Access Compliance Report

Public Rights-of-Way

(Curb Ramps)

Intersection ID: 47832	Main Street: TOM_SHORT_RD	Cross Street: CAMP_VERDE_LN	Location: NW
ADA ID: 4423784B87F9	Ramp Type: PerpDiag	Initial Pass/Fail: Fail	Overall Compliance: No
Severity Score: 8.75			
Codes/Mitigation Info/Possible Solution		Field Measurements/Component Compliance

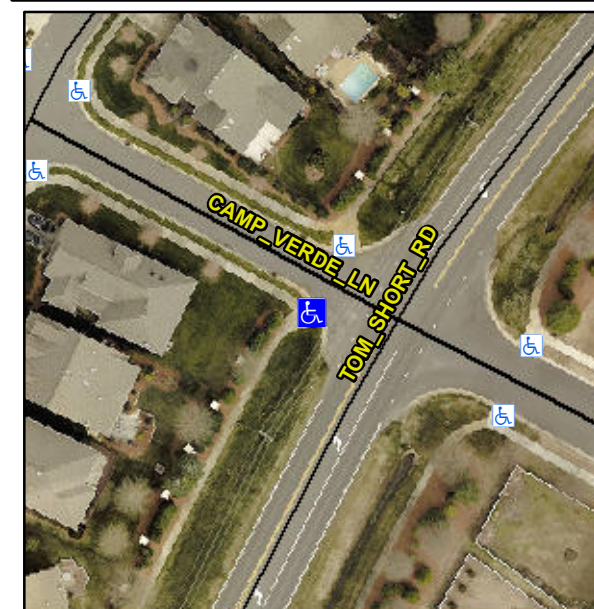
Compliance	Description	Data	Compliance	Description	Data
N/A	Ramp Length (in)	110.0	Yes	Ramp Slope (%)	7.9
No	Ramp Width (in)	44.0	Yes	Ramp XSlope (%)	0.1
N/A	Flare Type LT	N/A	N/A	Flare Type RT	N/A
N/A	Flare Slope LT (%)	N/A	N/A	Flare Slope RT (%)	N/A
N/A	Flare Traversable LT?	N/A	N/A	Flare Traversable RT?	N/A
N/A	Landing Length (in)	N/A	N/A	DWS Provided?	N/A
N/A	Landing Width (in)	N/A	N/A	DWS Contrast?	N/A
N/A	Landing Slope (%)	N/A	N/A	DWS Length (in)	N/A
N/A	Landing X Slope (%)	N/A	N/A	DWS Full Width?	N/A
N/A	Landing Curb? (Y/N)	N/A	N/A	DWS Offset (in)	N/A
N/A	Shared Landing?	N/A			
N/A	Gutter Ponding?	N/A	N/A	Gutter Slope (%)	N/A
N/A	Gutter Lip Ht (in)	N/A	N/A	Gutter X Slope (%)	N/A
N/A	Painted X Walk1?	No	N/A	Painted X Walk2?	No
	X Walk 1 Direction	To SE		X Walk 2 Direction	To NE
N/A	X Walk 1 Width (in)	N/A	N/A	X Walk 2 Width (in)	N/A
	X Walk 1 Slope (%)	3.5		X Walk 2 Slope (%)	1.4
	X Walk 1 X Slope (%)	0.2		X Walk 2 X Slope (%)	1.0

Remove & Replace Curb Ramp With Two New Directional Ramps or Equivalent.
